Item Name: Crosstube Turning Detail

DART AEROSPACE LTD	Work Order:	107543
Description: Crosstube Assembly (412 High Aft)	Part Number:	D412-664-243
Inspection Dwg: D412-664-243 Rev: E		Page 1 of 2

DRAWING NO. D412-664-243	TITLE CROSSTUBE ASS'Y (412 HI AFT)	REV. E	DART AEROSPACE LTD ENGINEERING ORDER		D.E.O. NO. D412-664-243-E-2	SHEET NO. SHEET 1 OF 1	SCALE NTS
DRAWN <i>92</i>	CHECKED <i>ASS</i>	MFG. APPR. <i>BE</i>	APPROVED <i>MP</i>	DE APPR. <i>MP</i>			
DATE 11.09.07	DATE 11.09.19	DATE 11.09.19	DATE 11.09.19	DATE 11.09.19

DRAWING NO. D412-664-243	TITLE CROSSTUBE ASSEMBLY (412 HI AFT)	REV. E	DART AEROSPACE LTD ENGINEERING ORDER		D.E.O. NO. D412-664-243-E-4	SHEET NO. SHEET 1 OF 3	SCALE NTS
DRAWN <i>90</i>	CHECKED <i>A</i>	MFG. APPR. <i>A</i>	APPROVED <i>MP</i>		DE APPR. <i>MP</i>		
DATE 12.08.21	DATE 12.08.30	DATE 12.08.30	DATE 12/8/30		DATE 12.08.30

**D412-664-243
ASSEMBLY DETAIL**

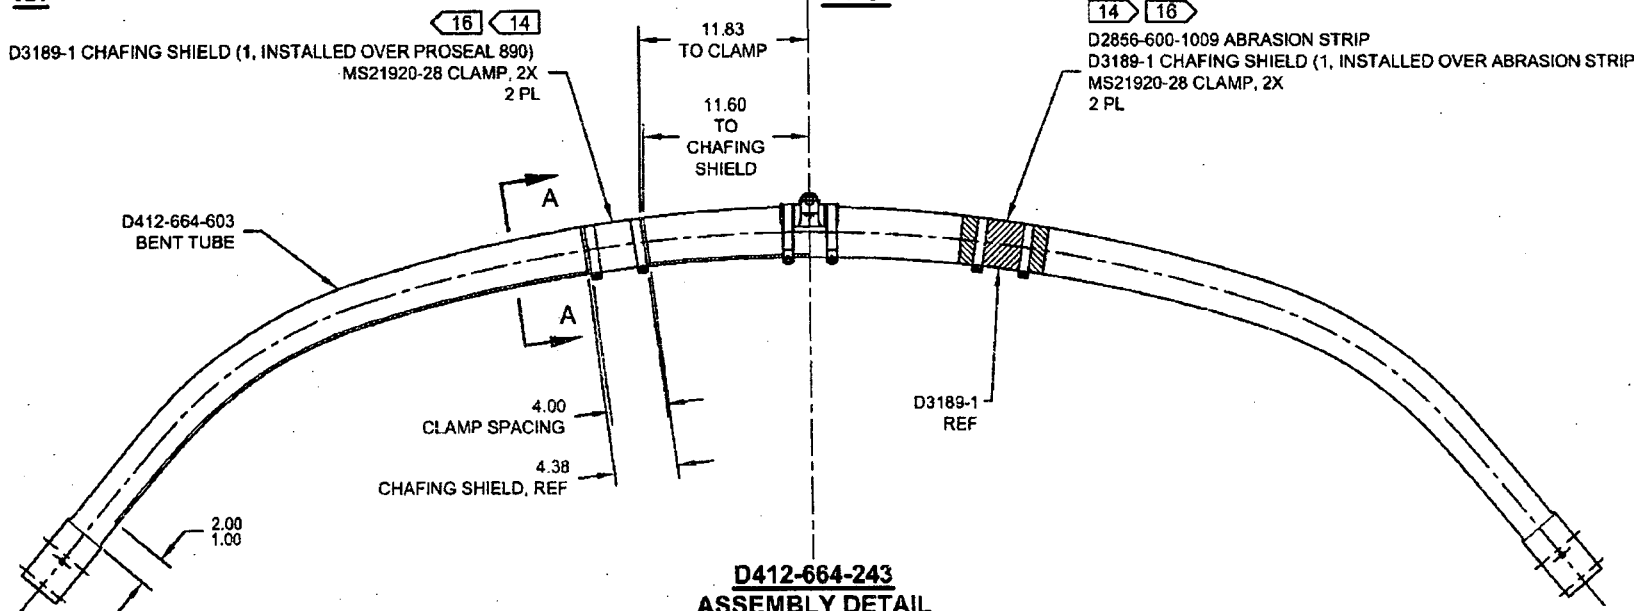
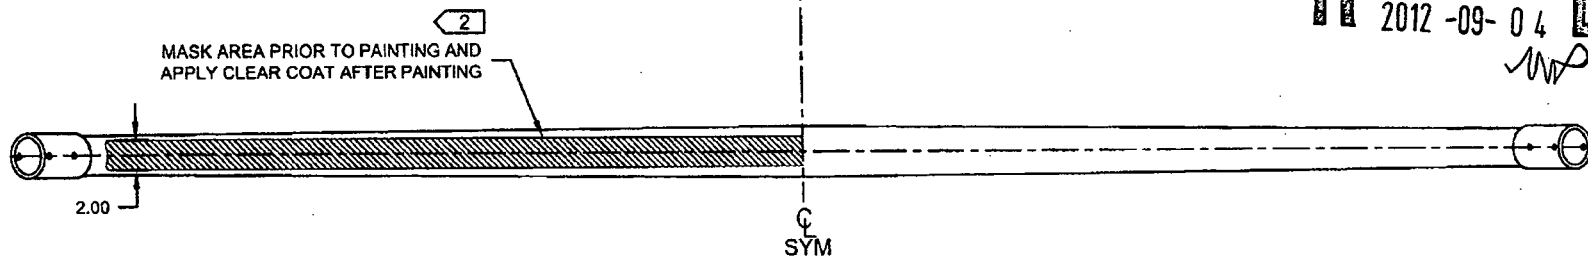
REMOVED ABRASION STRIP IN FAVOR OF A THIN LAYER OF PROSEAL 890. UPDATE INSTALLATION OF CHAFING SHIELDS AND REDUCE TORQUE TO 40-50 IN-LBS. THIS ENGINEERING ORDER SUPERCEDES DEO D412-664-243-E-1.

IS:

D3189-1 CHAFING SHIELD (1, INSTALLED OVER PROSEAL 890)
MS21920-28 CLAMP, 2X
2 PL

WAS:

D2856-600-1009 ABRASION STRIP
D3189-1 CHAFING SHIELD (1, INSTALLED OVER ABRASION STRIP)
MS21920-28 CLAMP, 2X
2 PL

SECTION A-A
CHAFING SHIELD DETAIL
VIEW ROTATED, NOT TO SCALE

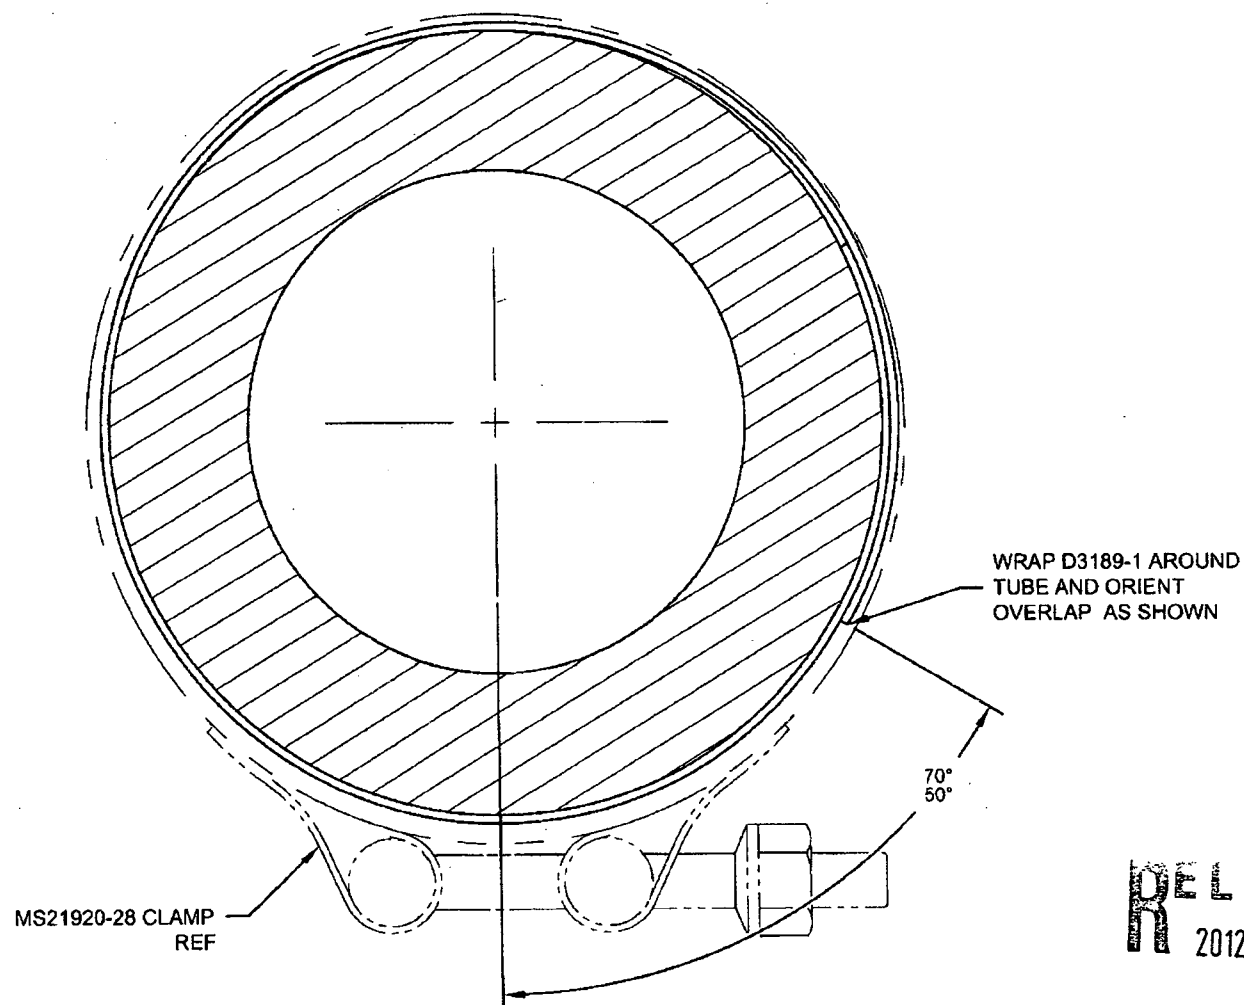
- 2) FINISH: CHEMICAL CONVERSION COAT PER DART QSI 005 4.1
PRIME INSIDE AND OUTSIDE PER DART QSI 005 4.2
MASK UNDERSIDE OF CROSSTUBE AS SHOWN (HATCHED AREA)
PAINT OUTSIDE PER DART QSI 005 4.2
AFTER PAINTING, APPLY CLEAR COAT ON HATCHED AREA
- 14) APPLY A THIN COAT OF PROSEAL 890 ON INSIDE CONCAVE SURFACE OF D3189-1 CHAFING SHIELD AND LET CURE PER MANUFACTURER'S INSTRUCTIONS. INSTALL PROSEALED D3189-1 CHAFING SHIELD ONTO CROSSTUBE BY APPLYING A THIN COAT OF PROSEAL 890 ONTO CROSSTUBE. BE SURE TO ELIMINATE ANY AIR GAPS.
- 16) TORQUE CLAMPS ON D2896-1 SUPPORT 80 TO 100 IN-LB. **TORQUE CLAMPS ON D3189-1 CHAFING SHIELD 40 TO 50 IN-LB.** ENSURE AT LEAST 1.5 THREADS SHOWING IN SAFETY AND THAT NUT HAS NOT BOTTOMED-OUT AFTER TORQUING.
